February 2nd, 2017
Peru State College, Theatre and Event Center Renovation and Addition
Peru, Nebraska

ADDENDUM #2

ADDENDA #2 TO SHEET D1.1
PERU STATE COLLEGE THEATER/EVENT CENTER
PERU, NEBRASKA

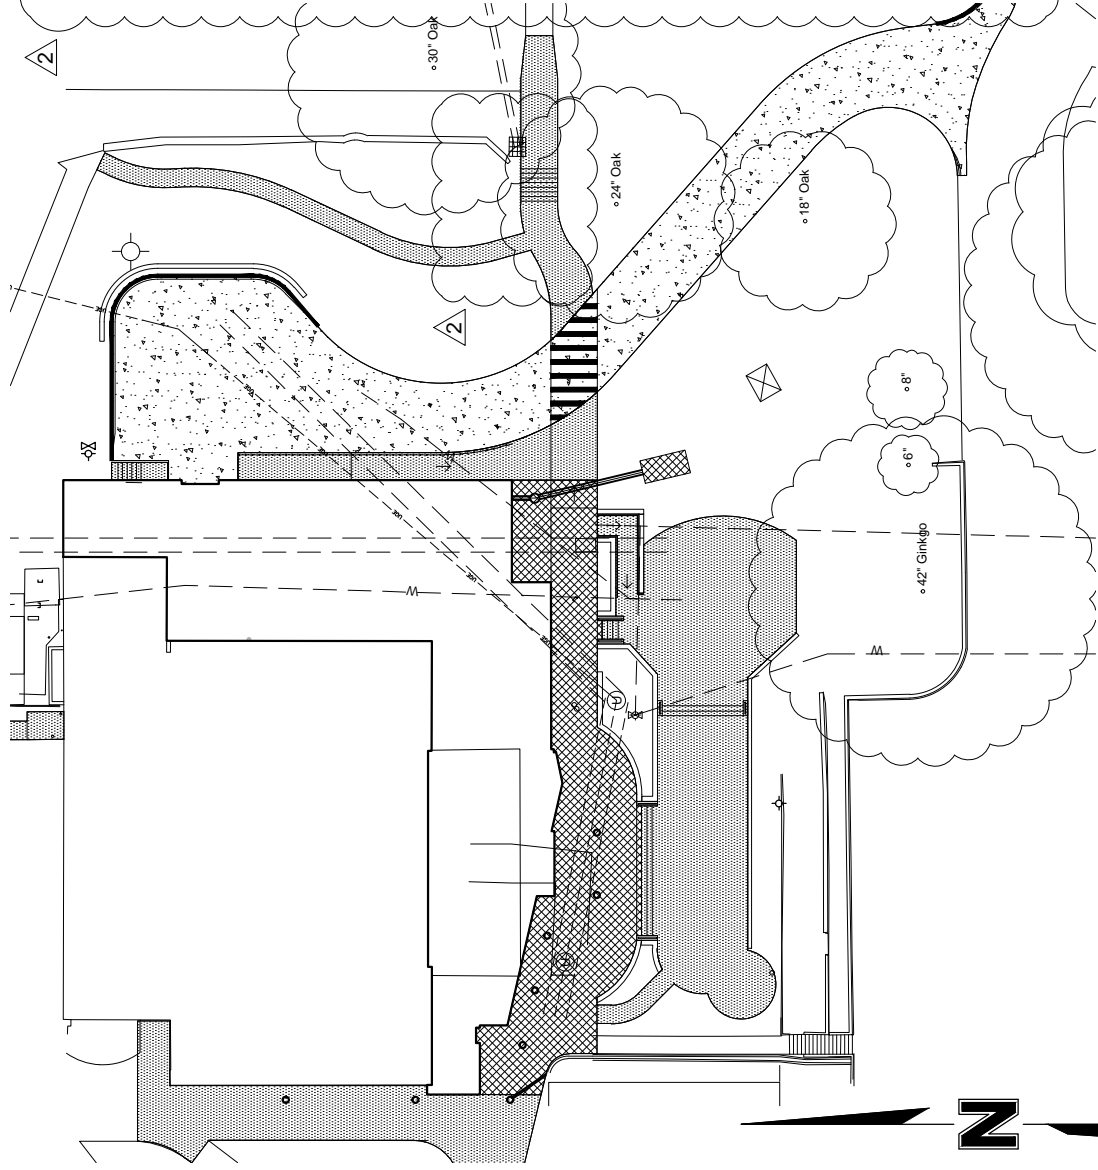
- A. See attached Addenda #2, Exhibit 1 – Revised drawing includes the removal of two additional trees.

△ ADDENDA #2 TO INCLUDE THE
REMOVAL OF TWO (2) ADDITIONAL
TREES ON SHEET D1.1

ADDENDA #2 TO SHEET C4.1
PERU STATE COLLEGE THEATER/EVENT CENTER
PERU, NEBRASKA

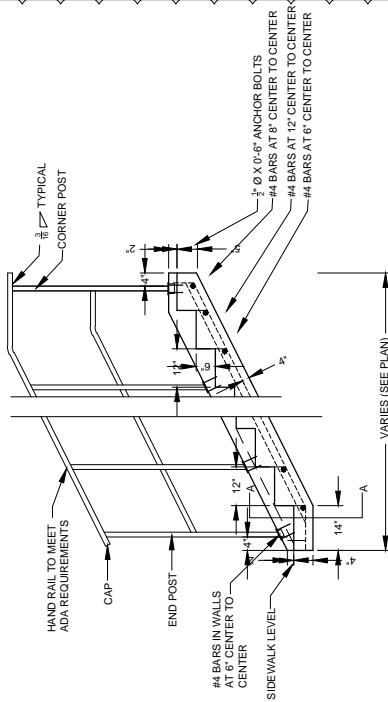
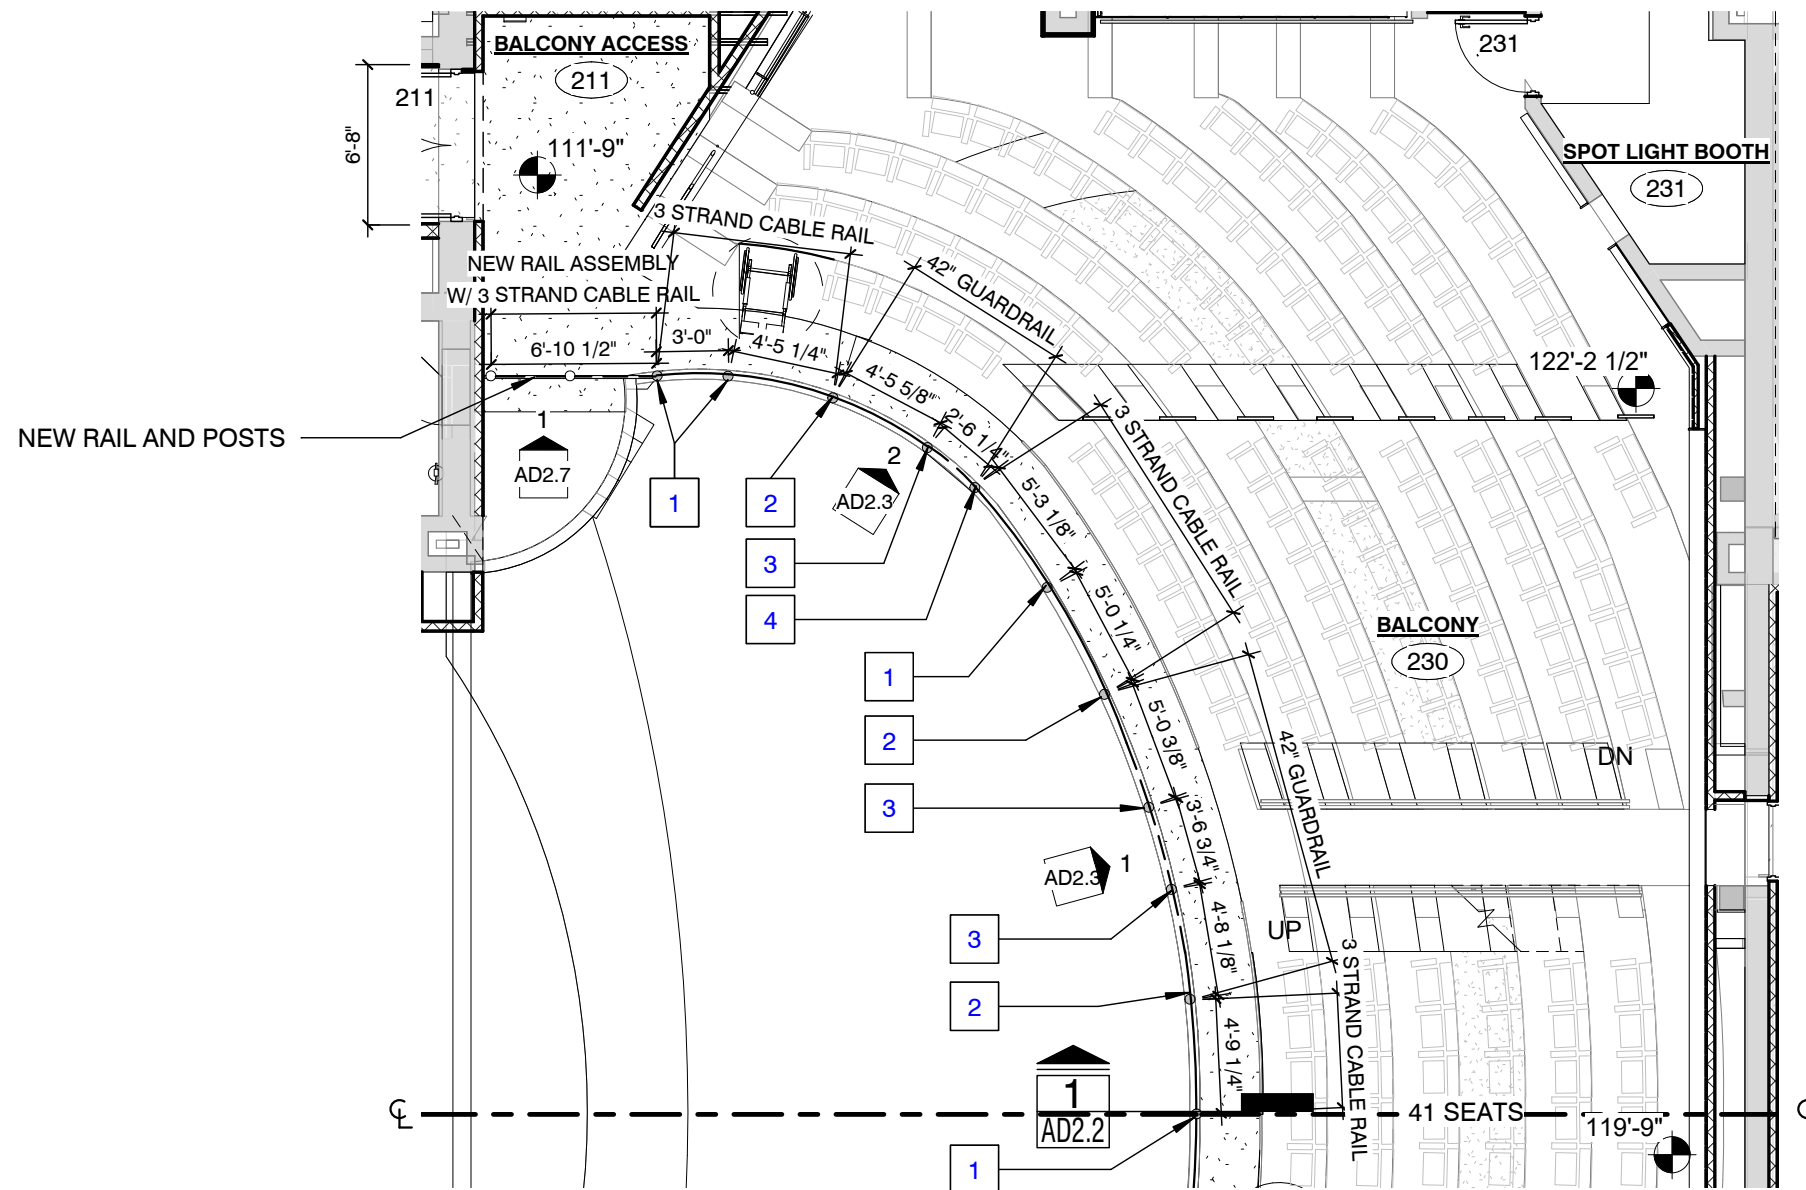
- A. See attached Addenda #2, Exhibit 2 – Drawing provides design for noted stair.

ADDENDA #2 TO INCLUDE THE
DETAIL OF STEPS AND HANDRAIL.

1 **MODIFIED 42" RAILING (MR-2) SECTION**
 AD2.4 1 1/2" = 1'-0"

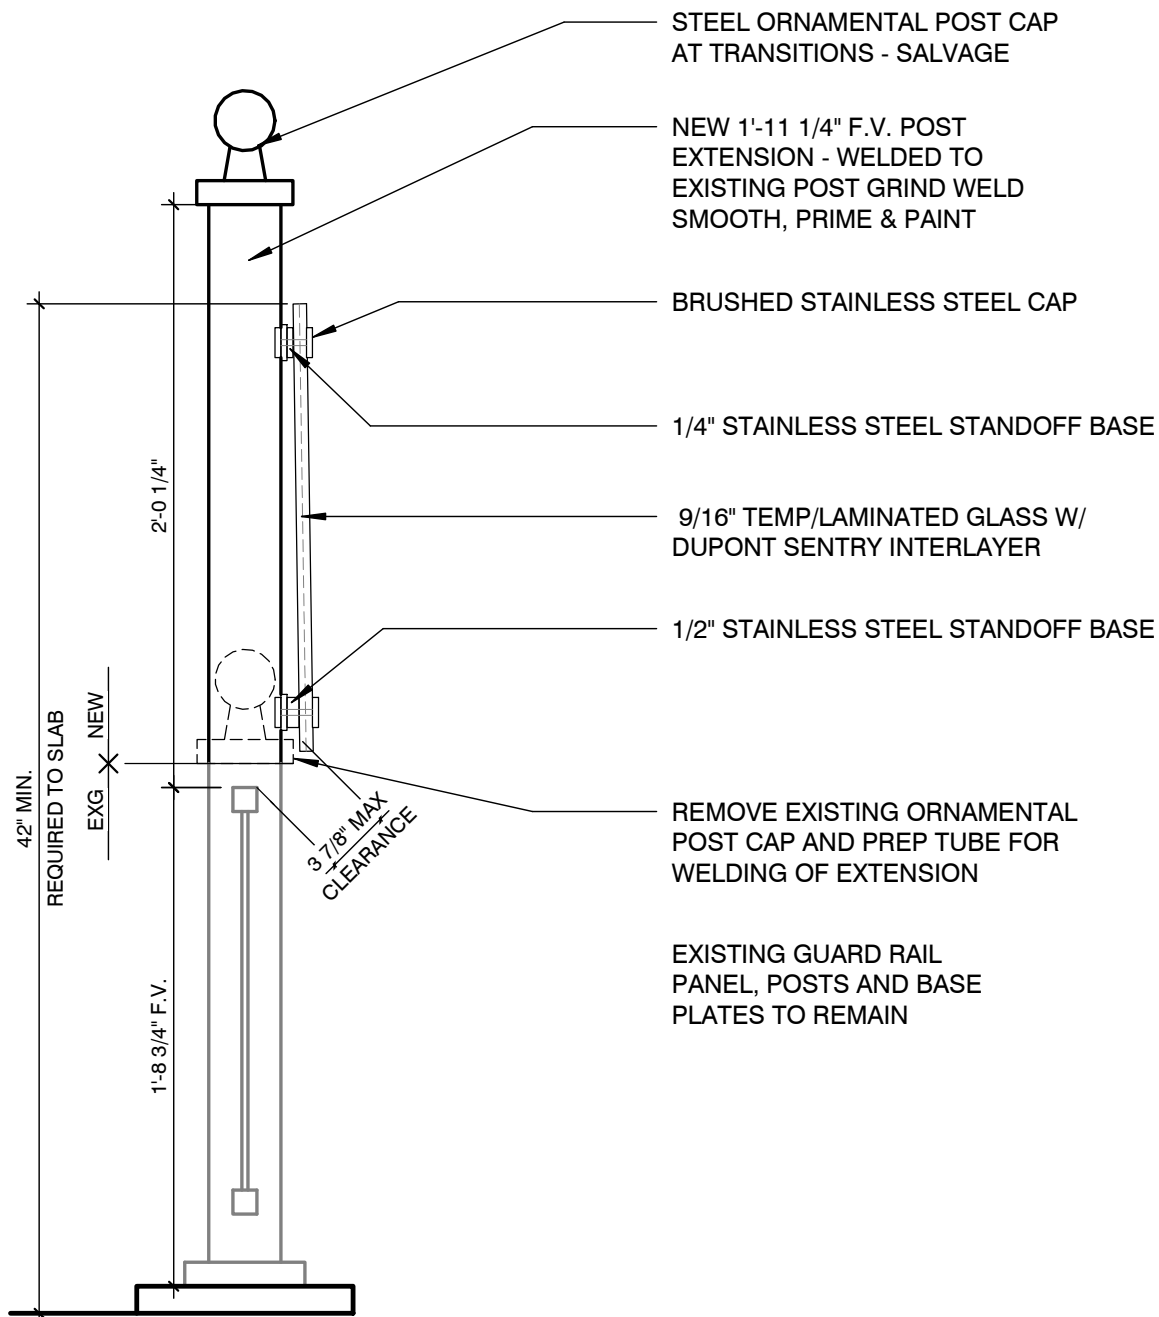
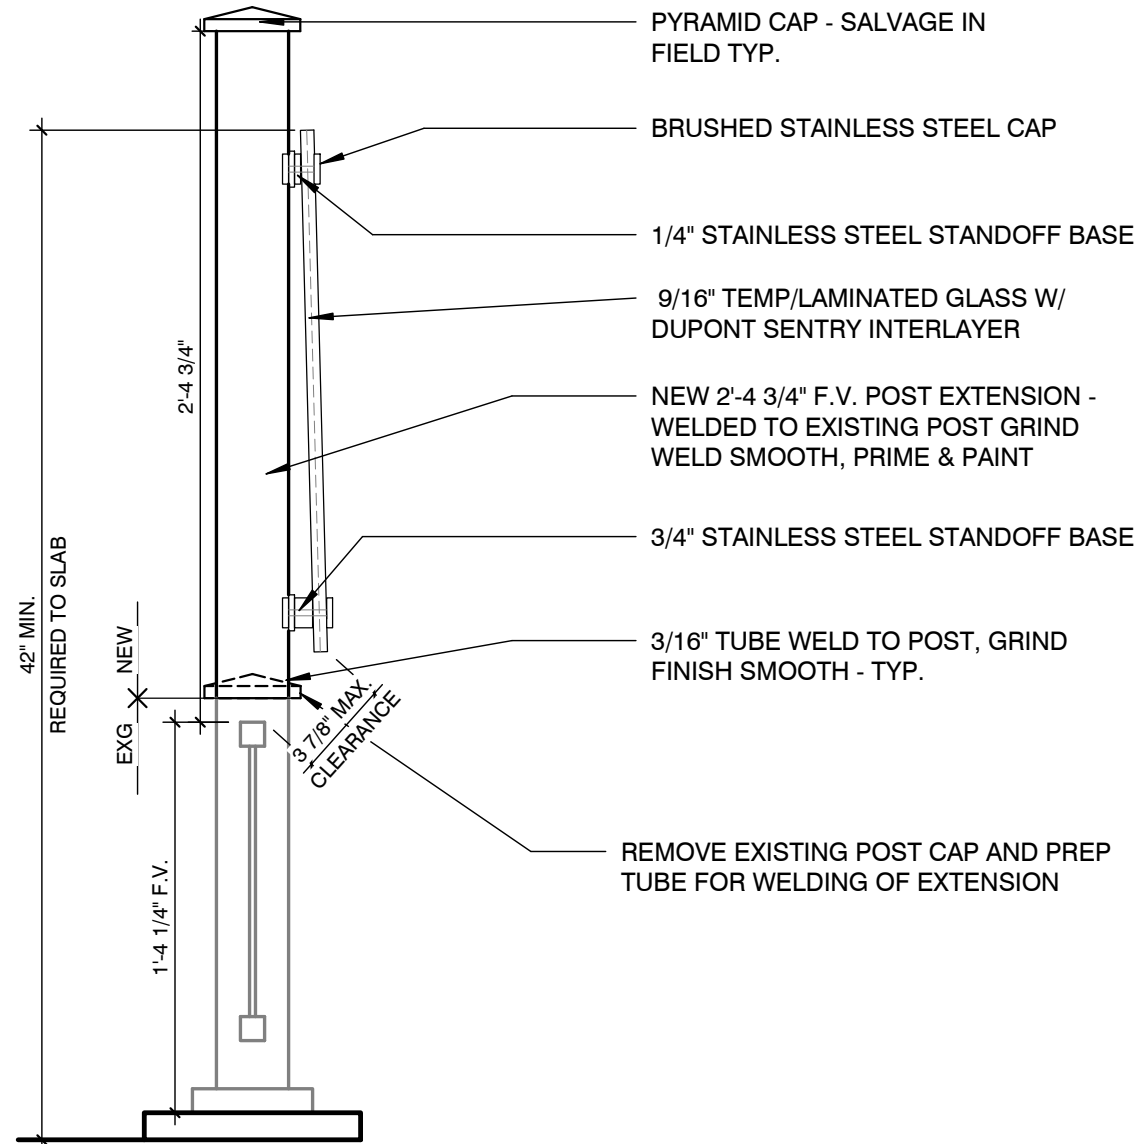
- A. 4/A8.4 – Replace this detail with Elevations noted on AD2.2
B. 5/A8.4 – Replace detail with sections on AD2.4.
C. 1/A8.4 – Replace detail with

1	EXISTING CONCRETE SLAB OVERLAY
A2-S1	SCALE: 1" = 1'-0"

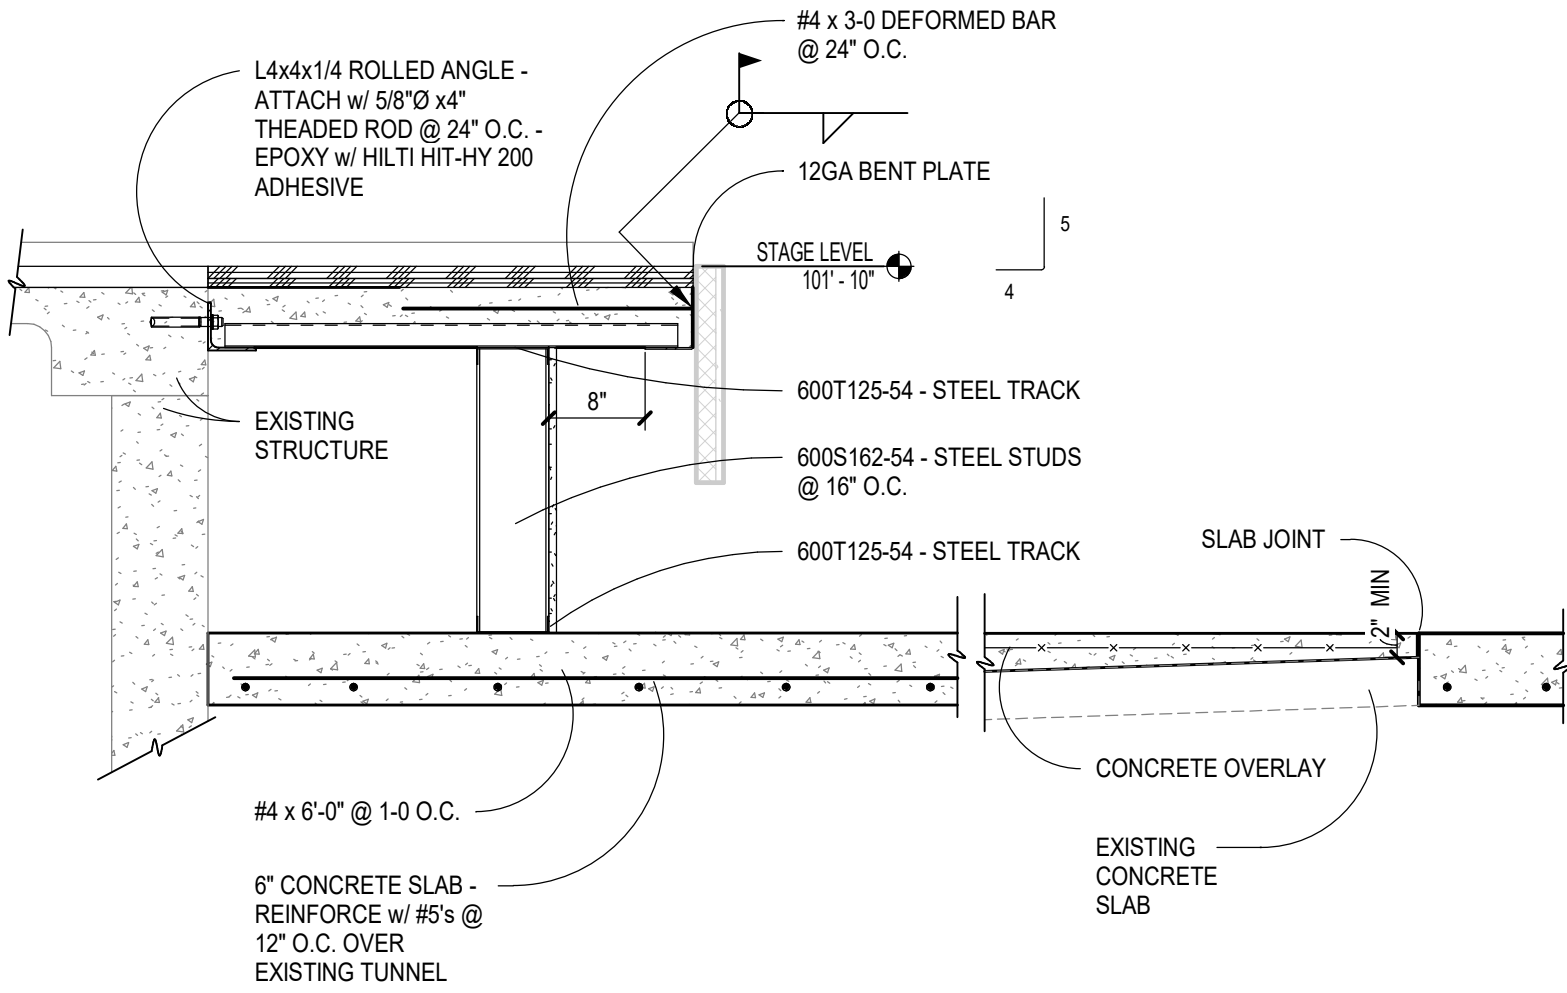
- ROUGHEN EXISTING CONCRETE SLAB SURFACE TO AN AMPLITUDE OF 1/4"
- REMOVE GREASE, OIL, PAINT, AND LOOSE CONCRETE FROM EXISTING SLAB
- CLEAN EXISTING CONCRETE SURFACE
- APPLY BONDING AGENT TO TOP OF EXISTING CONCRETE SLAB
- PROPORTION OVERLAY CONCRETE MIX WITH 3/8" MAXIMUM AGGREGATE SIZE, 0.45 W/C RATIO OR LESS, AND 4000 psi COMPRESSIVE STRENGTH
- SAW CUT OVERLAY SLAB AT EXISTING SLAB JOINTS

THIS DETAIL MAY BE USED AS AN ALTERNATIVE TO DETAIL E16/S3.1

1
A2-S2

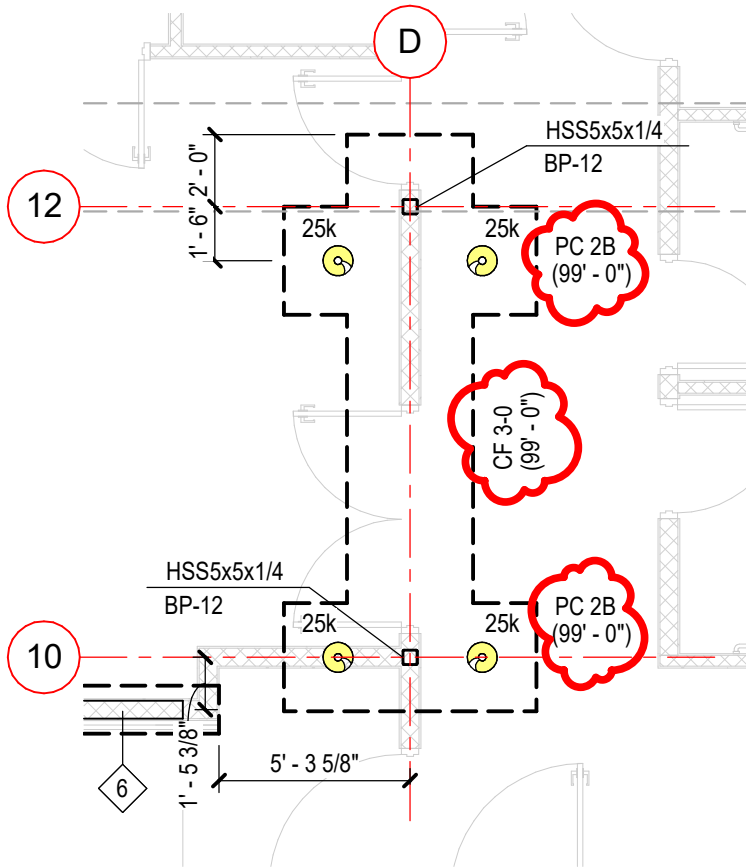
THIS DETAIL MAY BE USED AS AN ALTERNATIVE TO DETAIL J4/S3.1
